Technical Memorandum

To: Mr. Thomas Walker, FCAA Director of Operations
From: W. Kirk Martin, P.G., Water Science Associates
Date: August 12, 2016
Re: Review of Groundwater Flow and Transport Model of the Biscayne Aquifer
Prepared by Tetra Tech for Evaluation of Remedial Measures to Address the Hypersaline Plume Created by the Cooling Canal System at the FPL Turkey Point Power Facility

Figure 1. Net recharge (inches/season) applied in the seasonal calibration model.

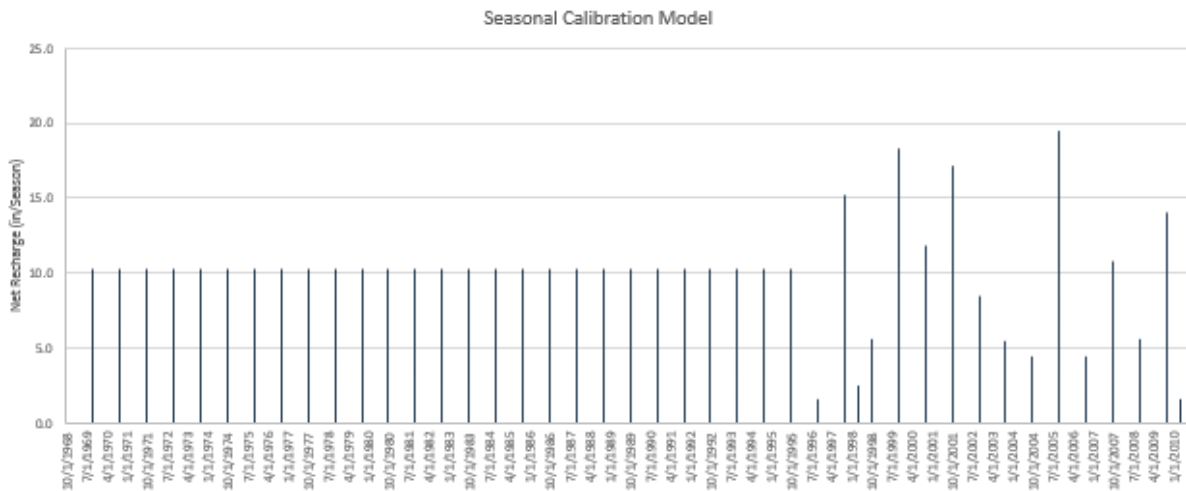
Figure 1 shows the net recharge applied in each stress period or season in the model at a selected location (R255 C21). It indicates that the most recharge occurs during the wet seasons as expected. A recharge of 10 inches per year in the wet season is applied uniformly from 1968 to 1995 whereas variable recharge rates are applied from 1996 through 2010 including net recharge being applied during the dry season in certain years. The technical memorandum does not indicate why the recharge rates were varied. Presumably, the change could be part of the calibration process. However, it is not clear why the recharge from 1968 to 1995 are uniform or why the change was made for years after 1995.

The net recharge in some years appears to be very high. For example, the net recharge was almost 20 inches in the wet season in 2005, which is about one third of annual precipitation. It should be noted that since the following figure only shows the recharge at one arbitrarily selected location, it might not necessarily represent the entire model area.

Figure 2. Dry cells in model Layer 1 at the end of stress period 1 in the monthly calibration model.

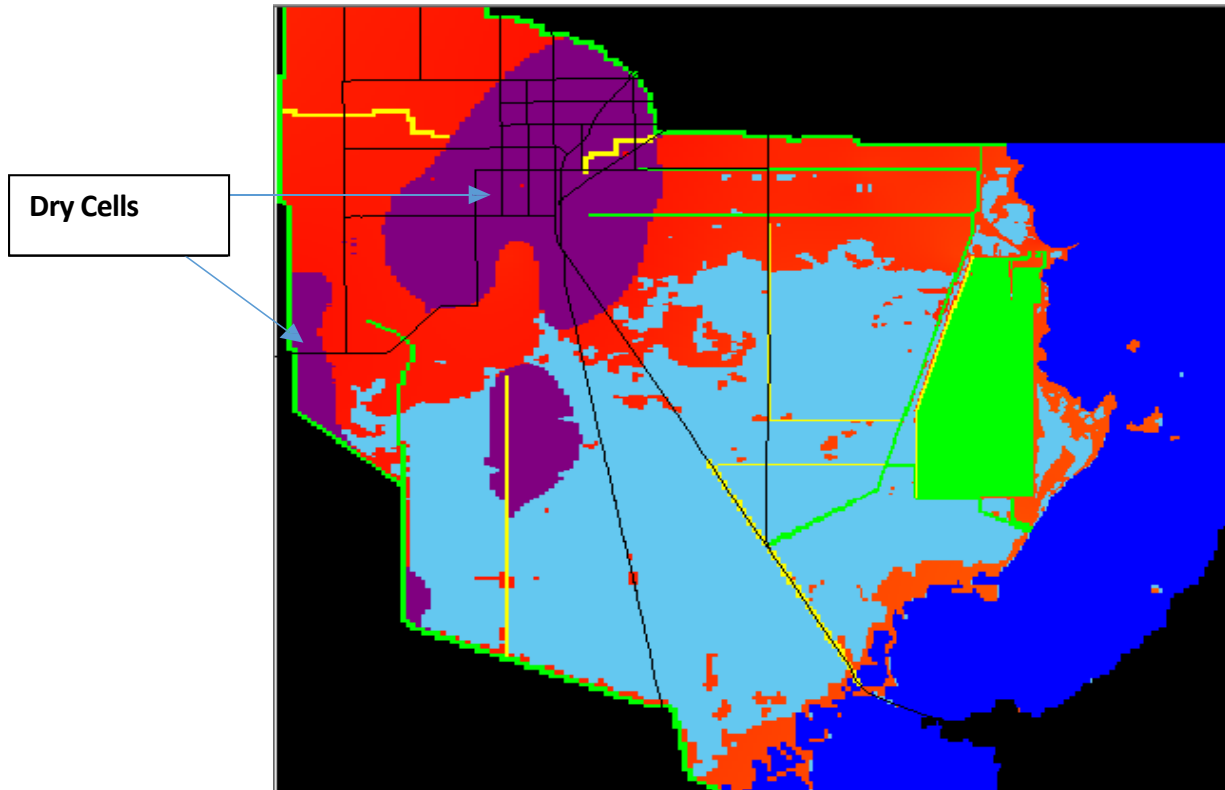
A large area of dry cells appears at the west side of the model with some dry cells appearing just after the first stress period in the monthly calibration model (Figure 2).

Table 1 shows the heads and bottom elevations at two cells located at the active-dry cell border at the end of stress period 1 in the monthly calibration model. In MODFLOW, a cell becomes dry when the simulated water level in the cell is below the layer bottom elevation. Simulated water levels drop from 0.929 feet at cell R55 C22 to a value below -0.758 foot at the adjacent cell (R55 C23) compared to the head change (0.05 feet) in underlying Layer 2.

Observation of the dry cells indicates that the river conductance along the C-111 canal, where dry cells are present, may be too low. The larger dry cell areas, appearing only in Layer 1 may not affect the simulation results but the model developers should investigate the reason for the dry cells.

Figure 3. Simulated water levels (ft, NGVD) for December 2015, in Layer 8.

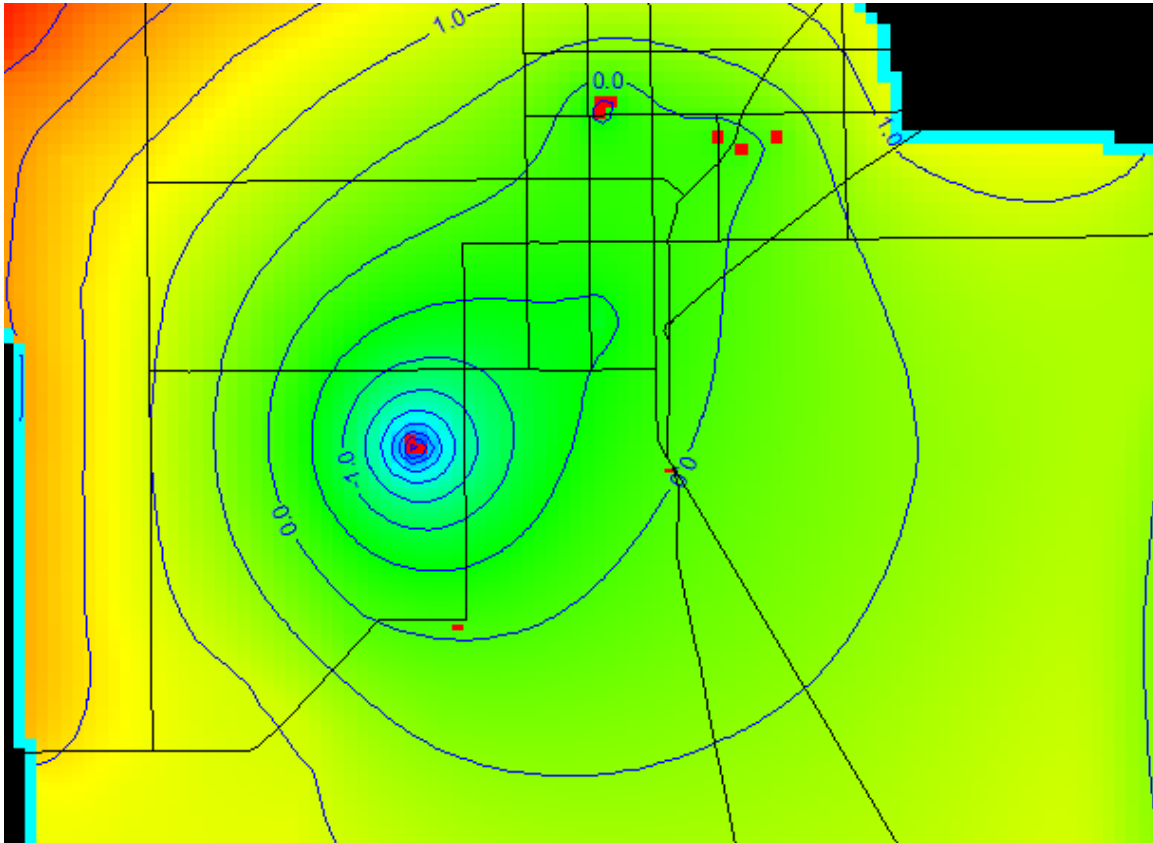
The model results also show a large area of drawdown due to withdrawals from the FKA wellfield (Figure 3). Such a large extent of cone of depression is not consistent with field measurements and likely represents an inaccurate simulation of the wellfield influence in an area of extremely high transmissivity. The effect of model boundary interference with wellfield drawdown may also be indicated.

Figure 4. Net recharge (inches/season) applied in monthly calibration model.

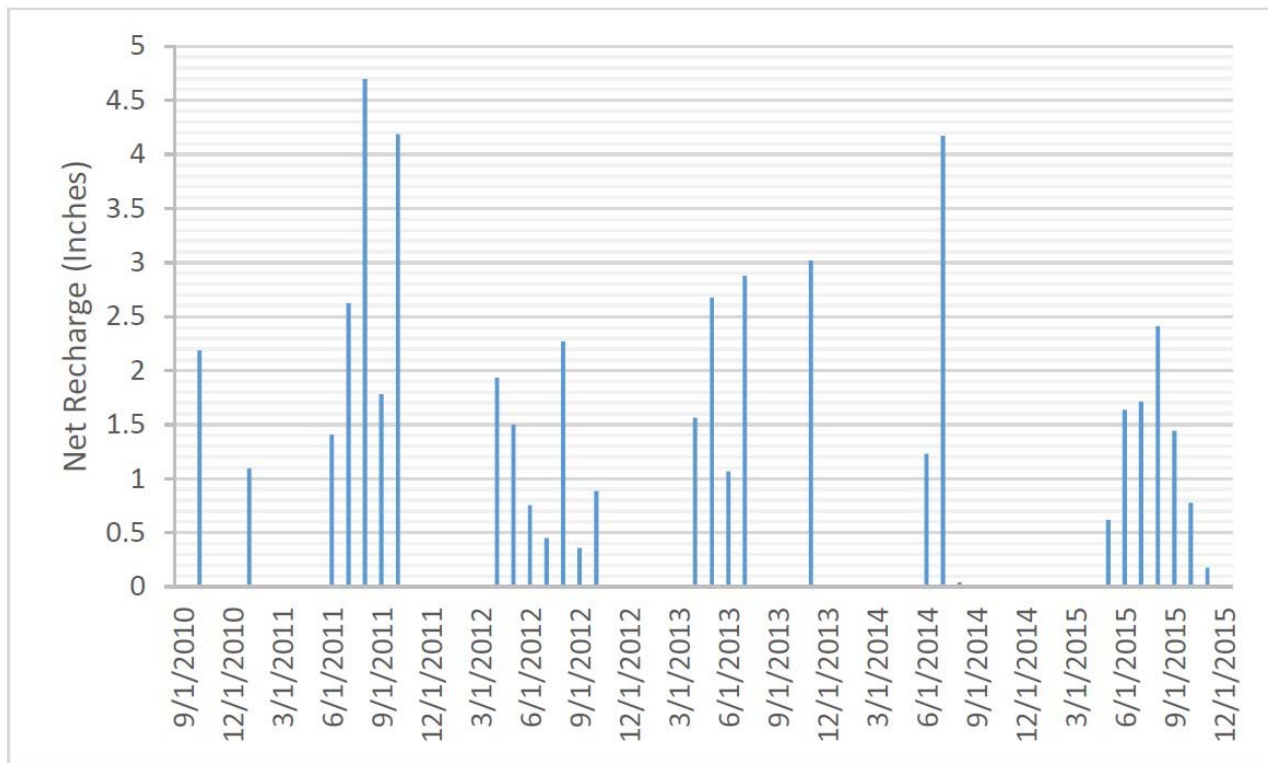
In addition to the dry cells, the model results also showed large areas where the cells were “flooded” when calculated water levels were above the land surface. The flooded cells may be caused by inadequately accounting for evapotranspiration in the model’s “net recharge” approach or by using non-representative hydraulic parameters in the shallow layers. Monthly net recharge rates at a selected location (R155 C21) are presented on Figure 4.

Figure 8. Performance of individual extraction wells in ALT3D (near UIC well is not shown).

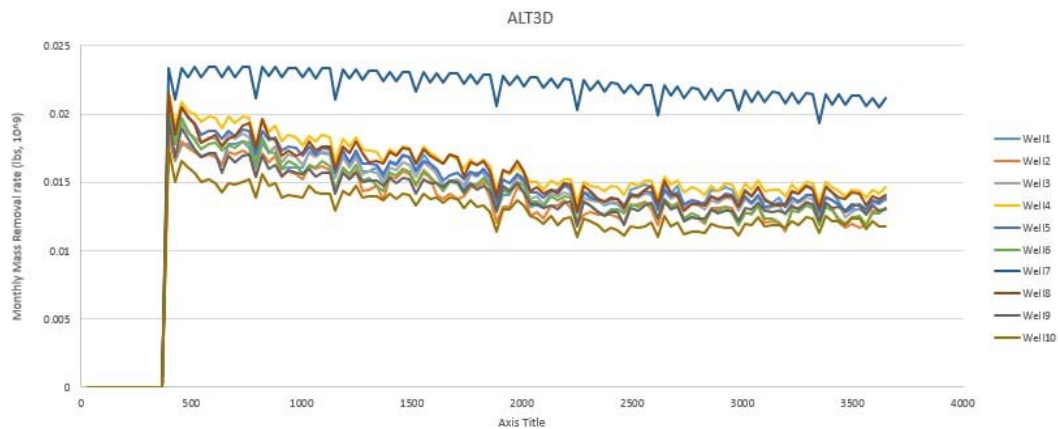
The performance of individual extractions (except the near UIC well), at the monthly mass removal rate, is shown on Figure 8. The proposed extraction rates for ALT3D scenario is provided in Table 4. It seems most of these proposed extraction wells behave similarly except for Well 7. The reason for better performance at Well 7 should be investigated. It follows that optimal location of proposed extraction wells may be determined by looking into the performance of each well.

It would be of interest to see if a higher efficiency of extraction of the hypersaline plume and seaward movement of the saline water interface could be achieved with the location of the extraction wells more towards the middle of the hypersaline plume. It would also be beneficial to look at the mass removal rate of each extraction well, as shown in Figure 8 for ALT3D, to optimize the remediation system design.

Figure 11. Simulated head changes in model Layers 1-4 in seasonal calibration model.

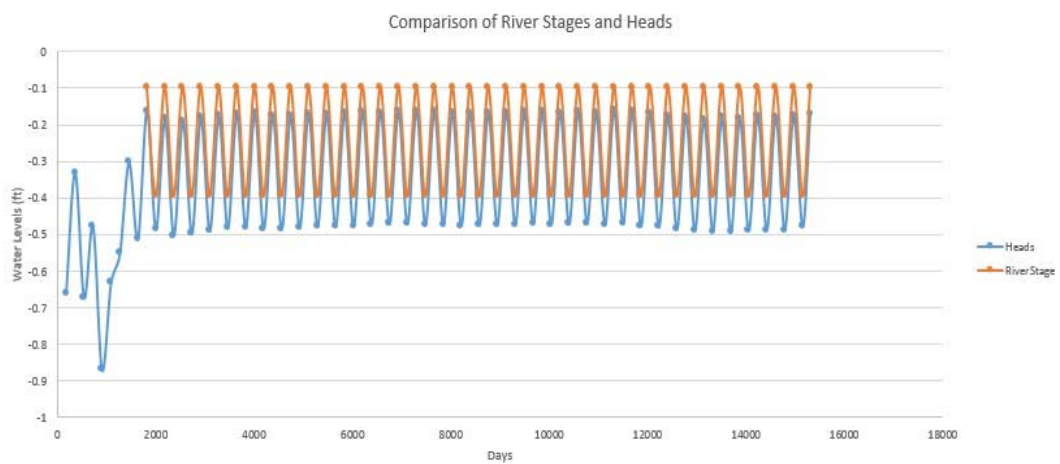
Layers 1 through 11 are hydraulically well connected and water levels in these layers fluctuate in a similar fashion. As indicated on Figure 11, a slight offset of about 0.05 feet is noted between the simulated water level in Layer 1 and stage values in the canal. The salinity in the aquifer is also very similar to the salinity specified in the CCS at the selected location as indicated on Figures 14 and 15.

Figure 15. Simulated salt concentration changes in model Layers 5, 7, 9, and 11 in the seasonal calibration model.

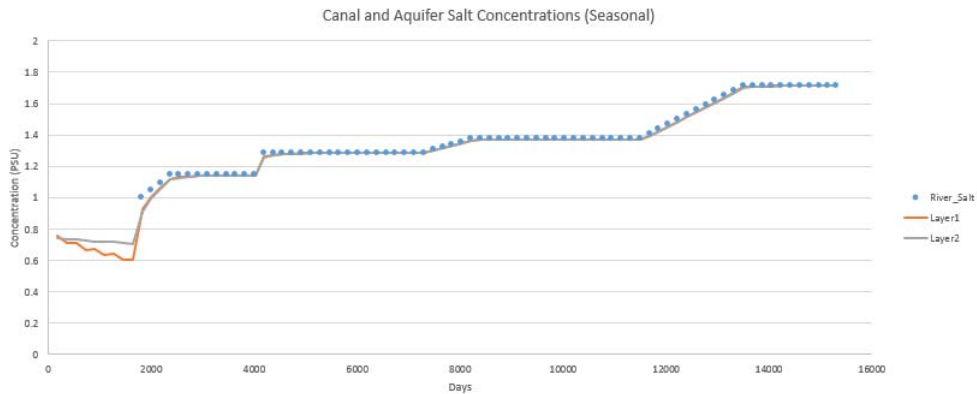
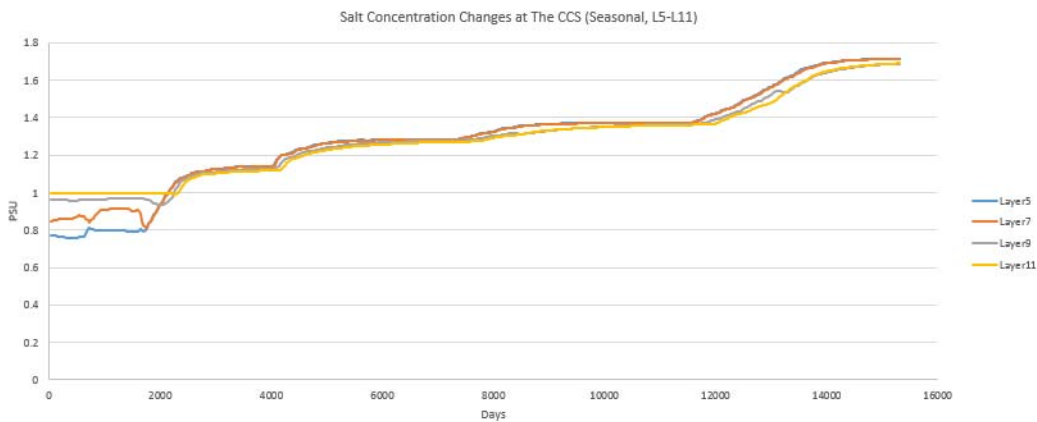
As shown on Figure 15, the maximum salinity in the CCS simulated in the seasonal model is about 1.8 PSU. It is relevant to note that salinity as high as 3.0 PSU has been reported for CCS (Chin, 2015). Higher salinity, up to about 2.7 PSU as shown in Figure 17, was applied to the CCS in the monthly model. However, due to change in canal conductance at that time, the salinity in deeper layers appears to not be impacted by the salinity in the CCS. It needs to be understood why the simulated salinity does not match the observed peak salinity values in the canal and how the low conductance in canal post 2013 is affecting the salinity in lower model layers.

Figure 16. Simulated water levels in the CCS canal and model Layer 1 in monthly calibration model.

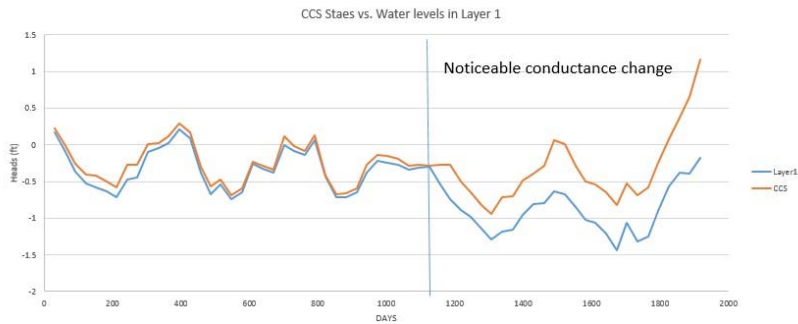
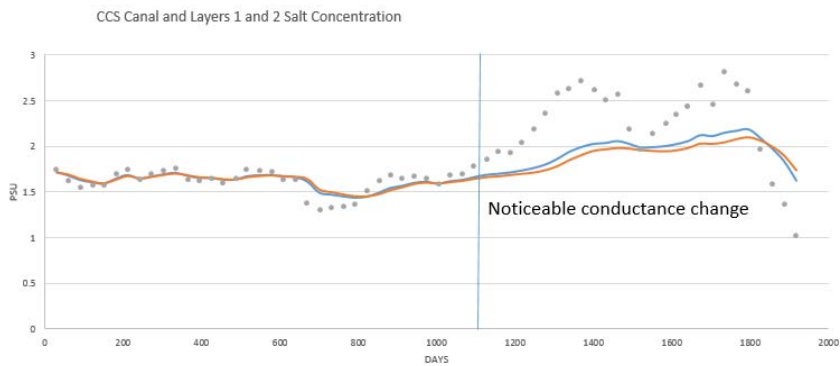
was made towards the end of the calibration period, and it seems to have occurred only at the CCS area. However, the change indicates a very different set of conditions for the remediation simulations as compared to the model calibration efforts. The impact of this change may also significantly affect the simulation results as shown in Figures 16 and 17.

Review of the figures indicates that the simulated heads and salinity start to deviate from the values specified in the CCS after the river conductance values are reduced. This impact is also observed in the model calibration time series (from the Tetra Tech PowerPoint presentation presented as Figure 18).

Figure 18. Salinity calibration results of the monthly model (Tetra Tech, 2016).

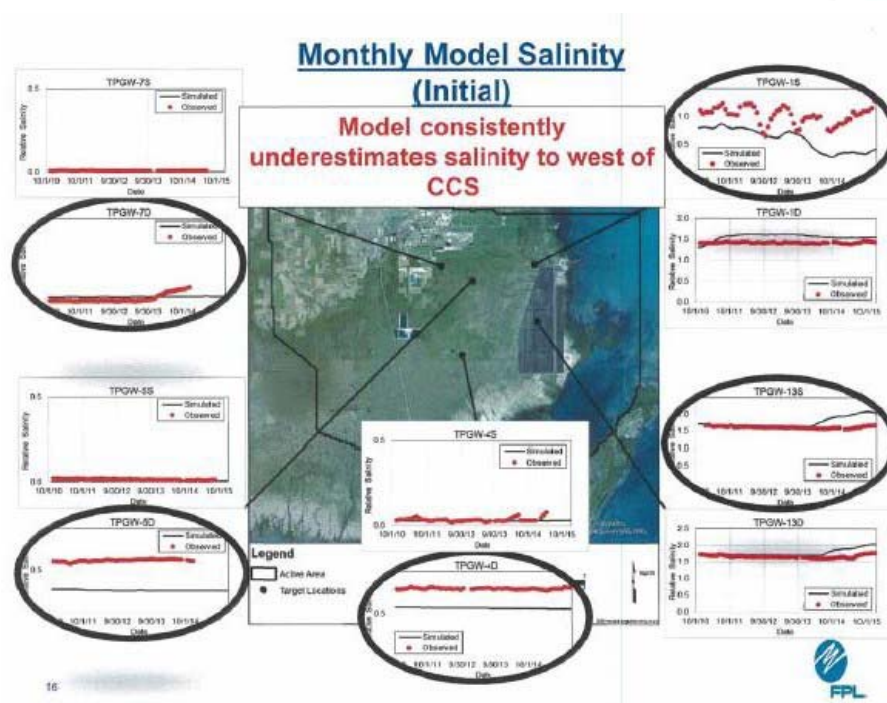
As shown above, simulated salinity values in the calibration target monitor wells, TPGW-13S and TPGW-13D, started moving away from observed values at approximately the end of 2013. Another monitoring well, TPGW-7D, located a significant distance away from the CCS, also showed a similar pattern change. The revised river conductance values for the CCS were used in all of the predictive models. This is a concern. The change of the river conductance beneath the CCS was significant and made at a very late stage of the model calibration period. The reduced river conductance may not be representative of actual field conditions and was not considered during most of the model calibration period. The validity of the prediction scenarios are therefore placed in question because of the significance of the change and the late stage of the change in the area most critical for performance evaluation of the proposed remediation measures.
